**TO:** Scott Boduch, Rogue Architecture  
**FROM:** BrieAnna Simon, Associate Planner  
**DATE:** February 17, 2022  
**SUBJECT:** Horseshoe Ridge AMD 1 L2 B1 - Commercial Multitenant  
Site Plan Adjustment – SP22-007 Review Comments v1

# HORSESHOE RIDGE SUBDIVISION 1ST AMENDMENT

# PARKER MIXED-USE RETAIL

SHEET: **A-2**

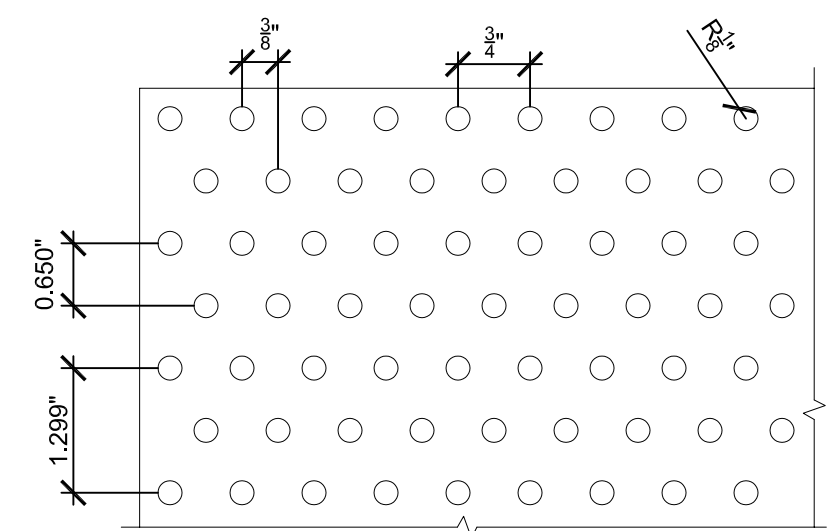
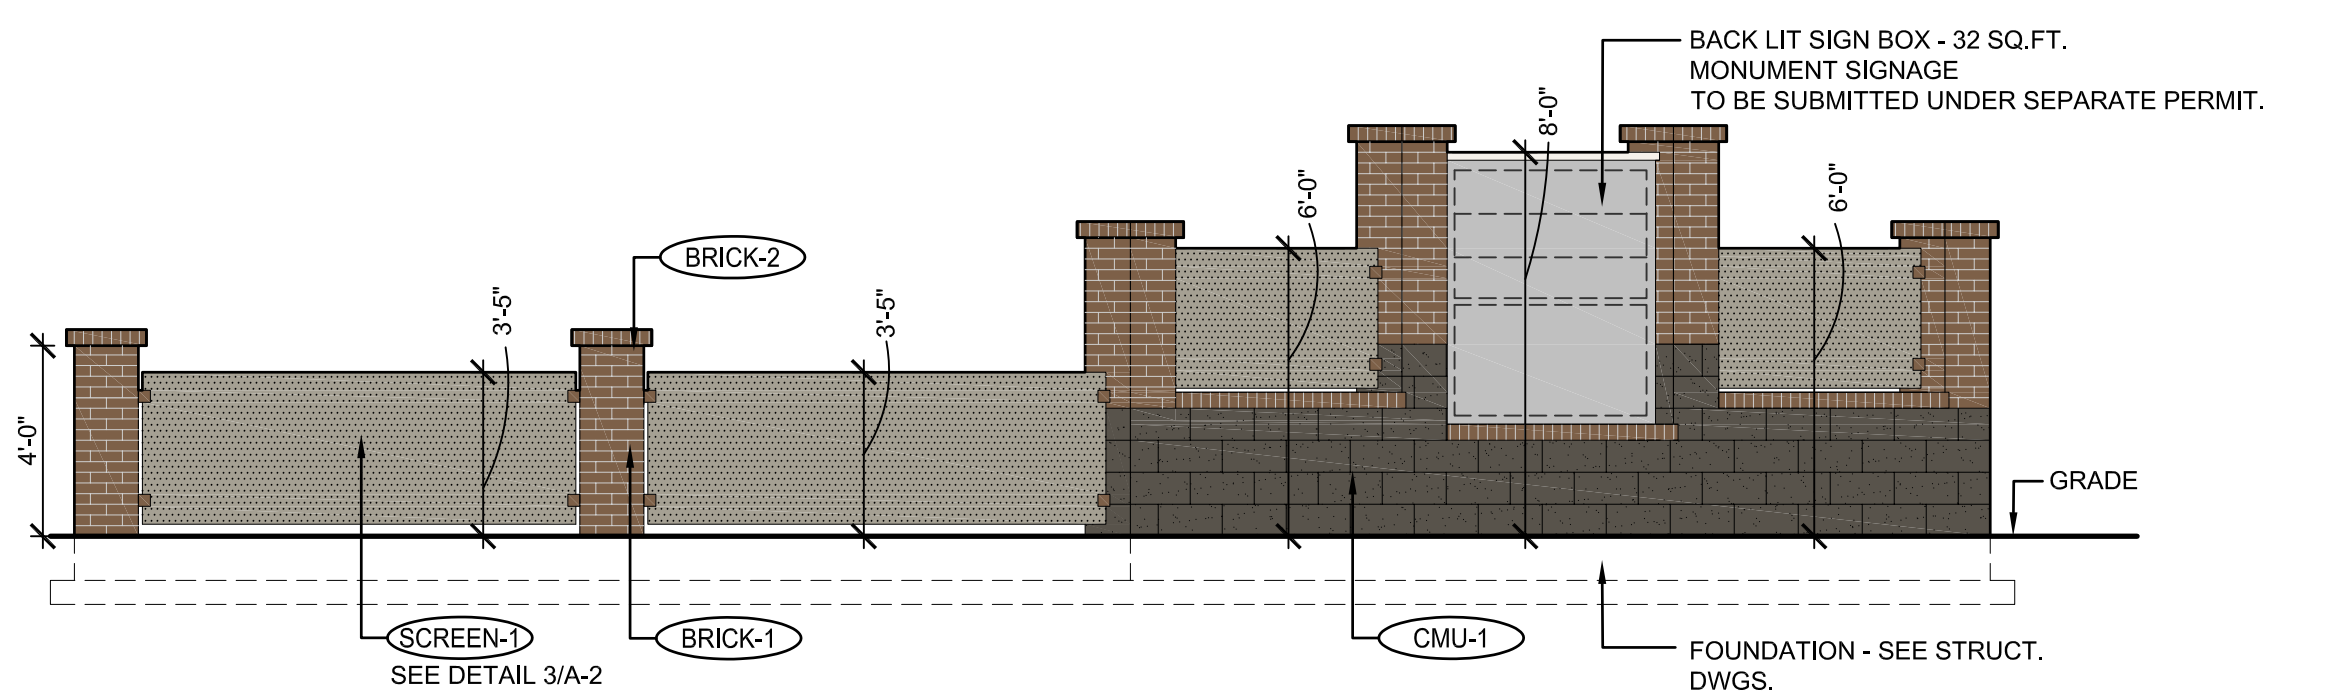
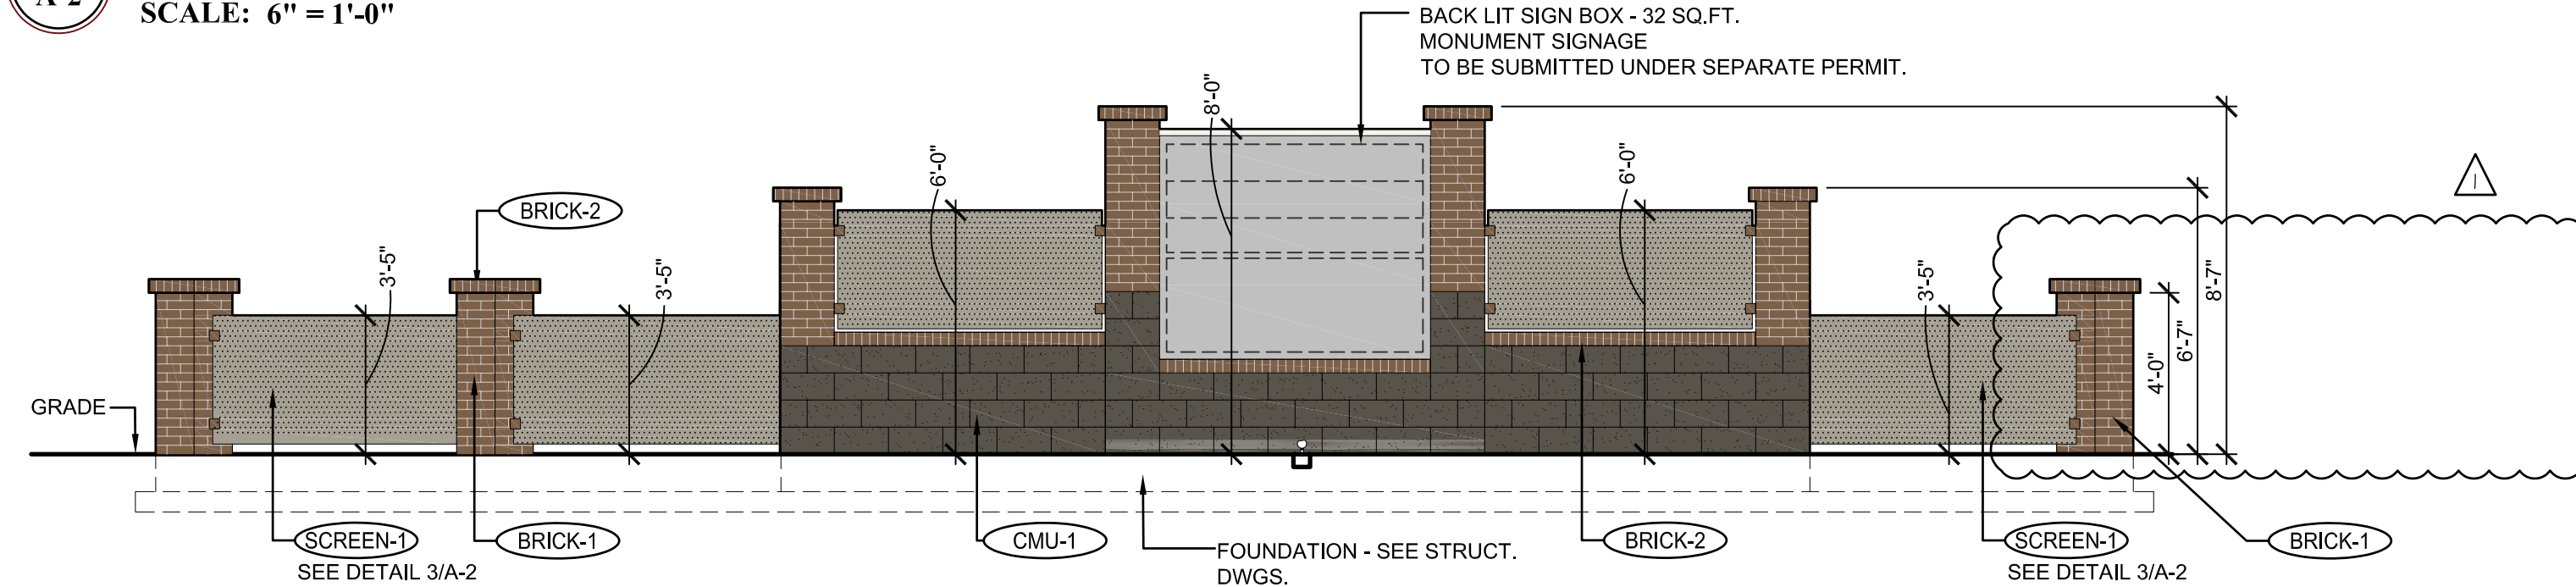
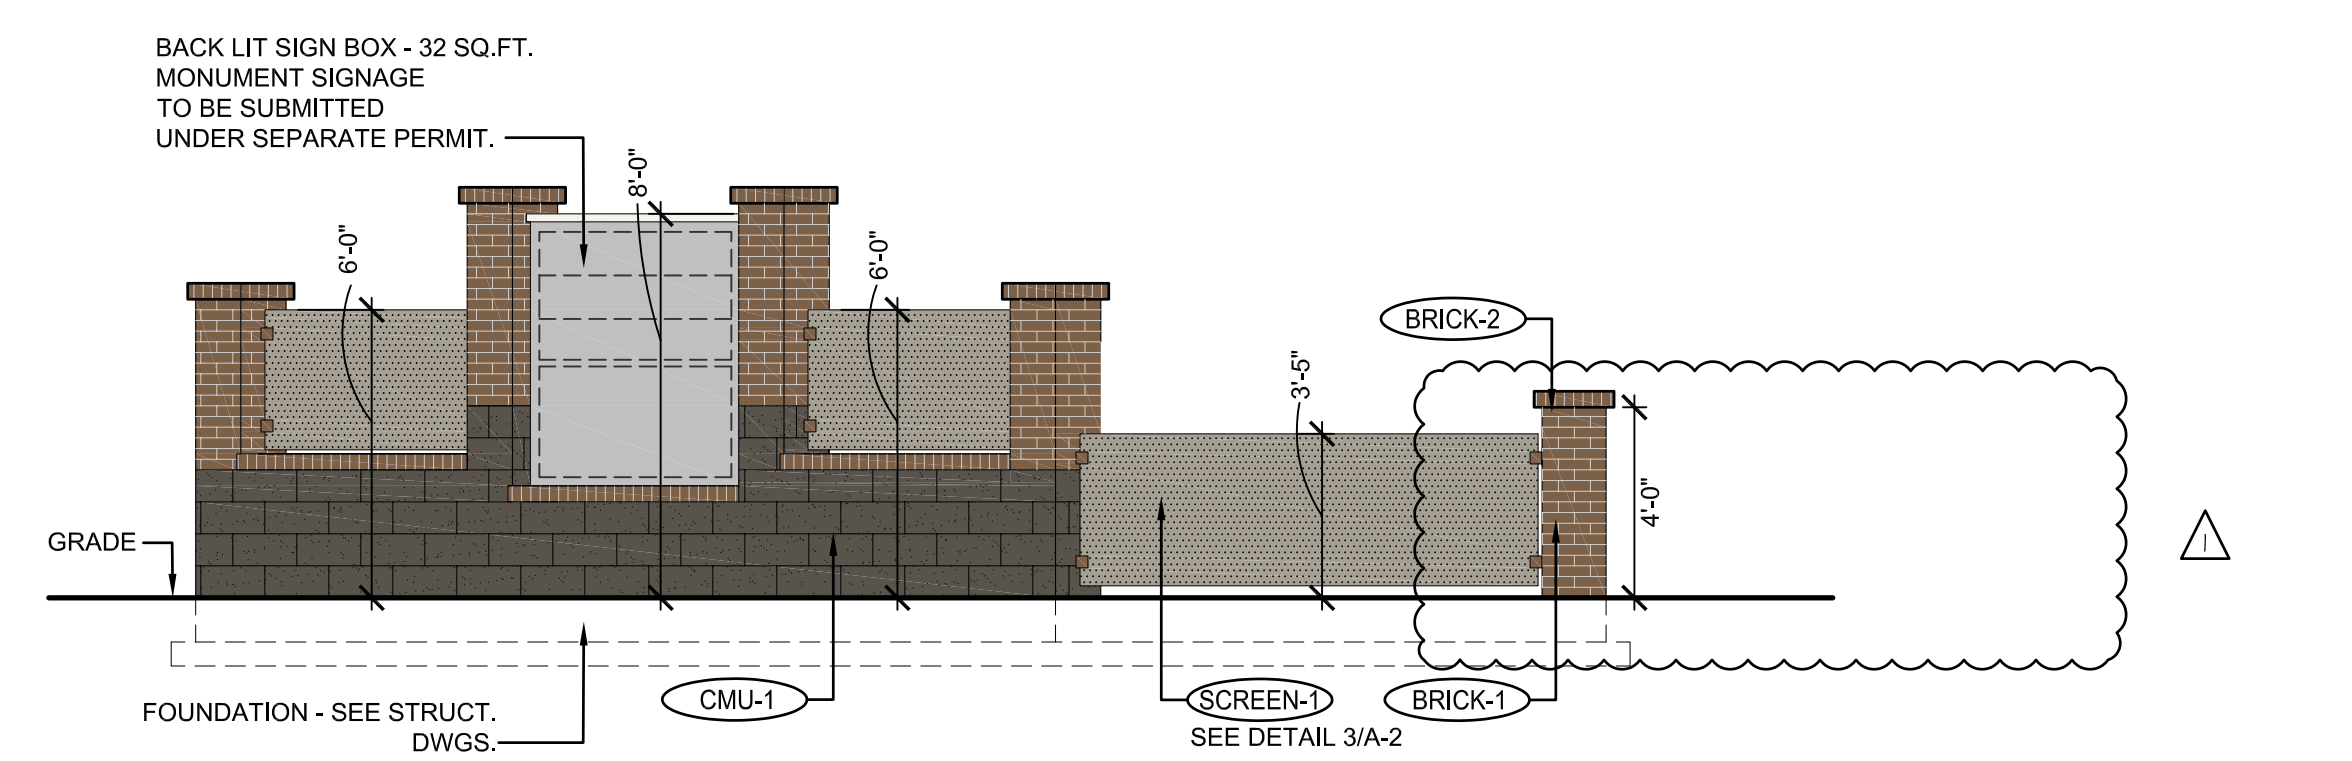
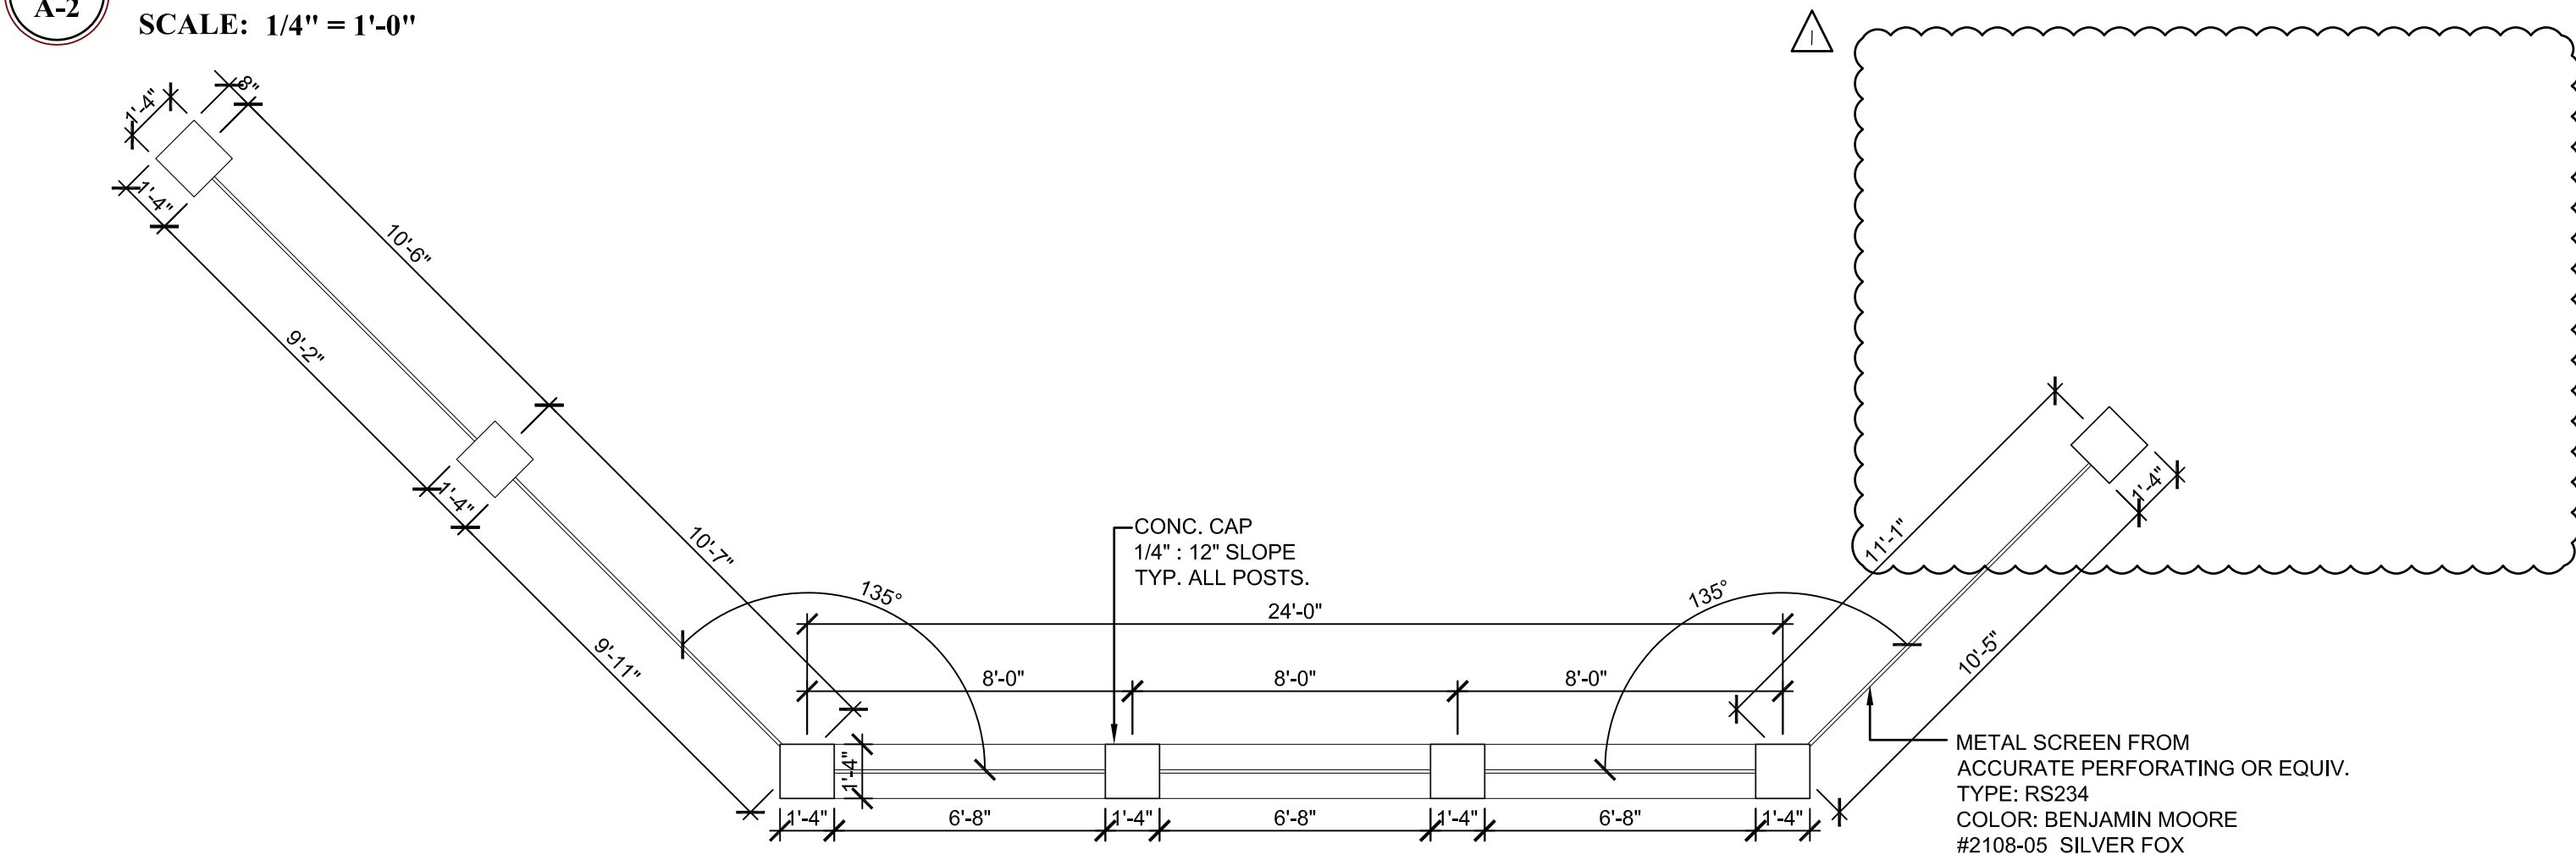
Please be sure the window types (Storefront 1 and Glazing 1) match the building permit.

SHEET TITLE  
**LANDSCAPE PLAN**

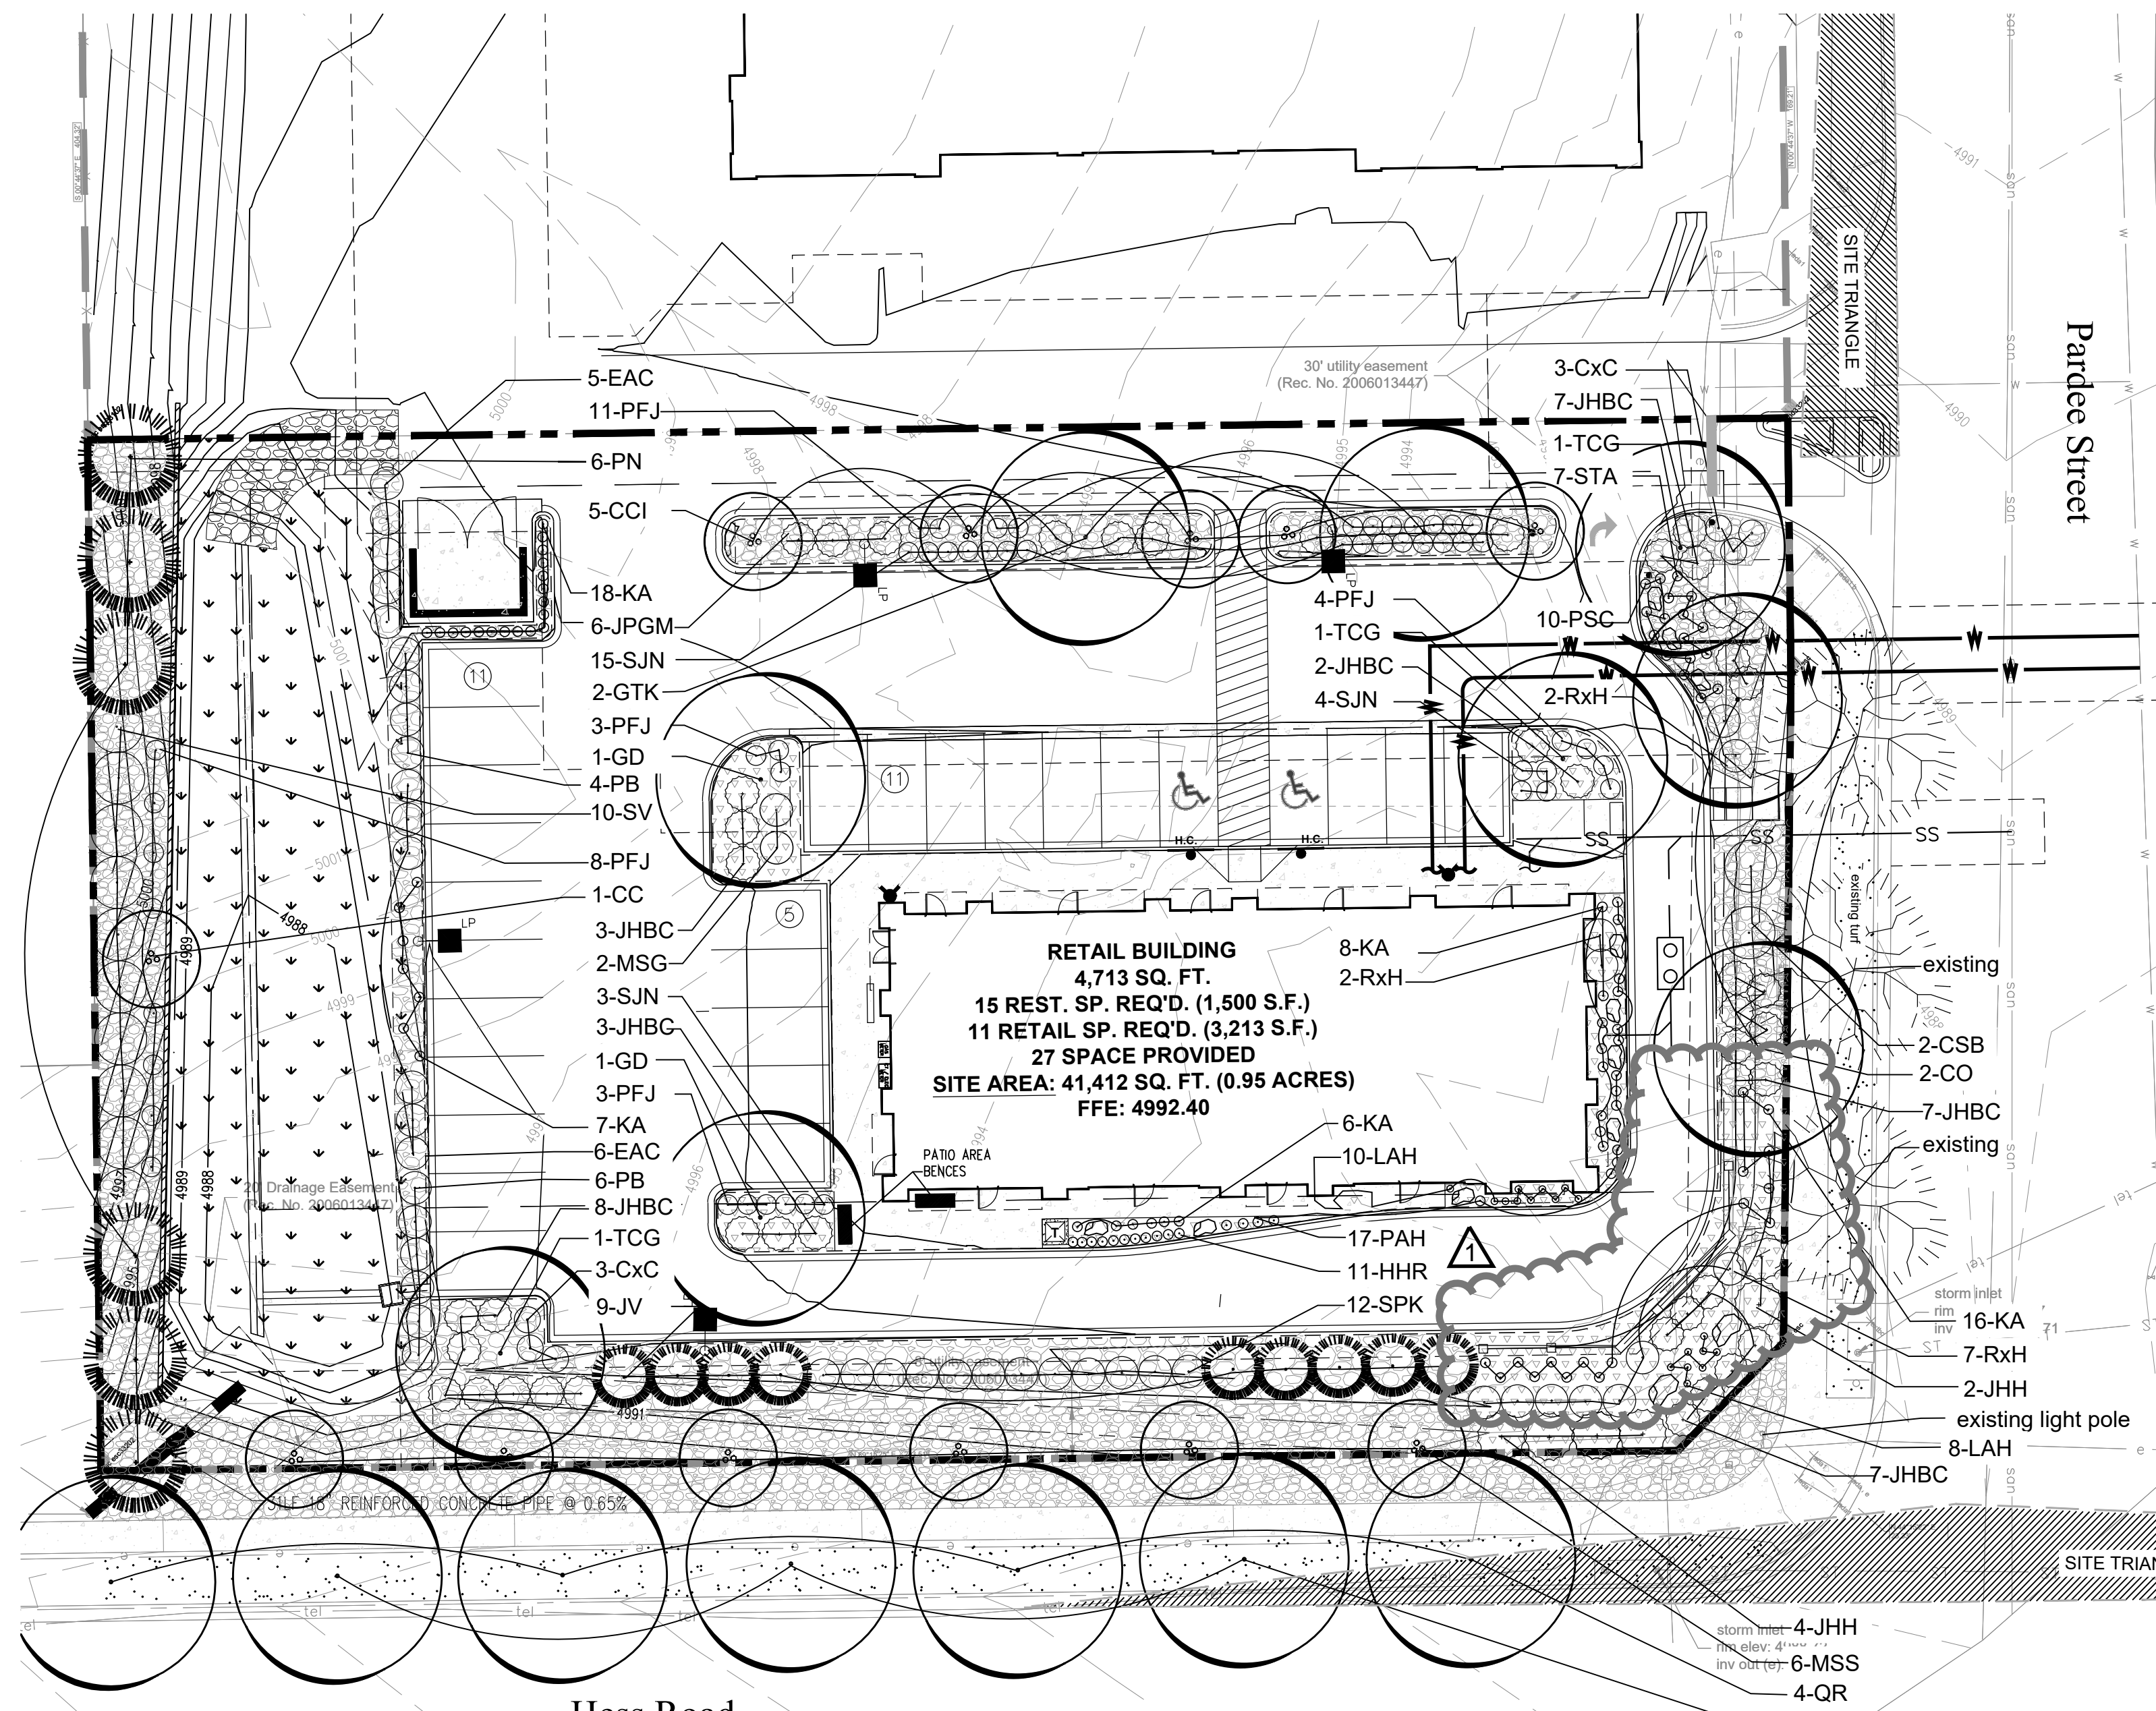
No changes are shown on this plan compared to the approved site plan.

Please show how the landscaping will be changed due to the increased impervious surface and new transformers. Please update/show how the tables and the plant schedule to the right will be change and still meet the Town's landscape requirements. All minimum Town requirements are required to be met.
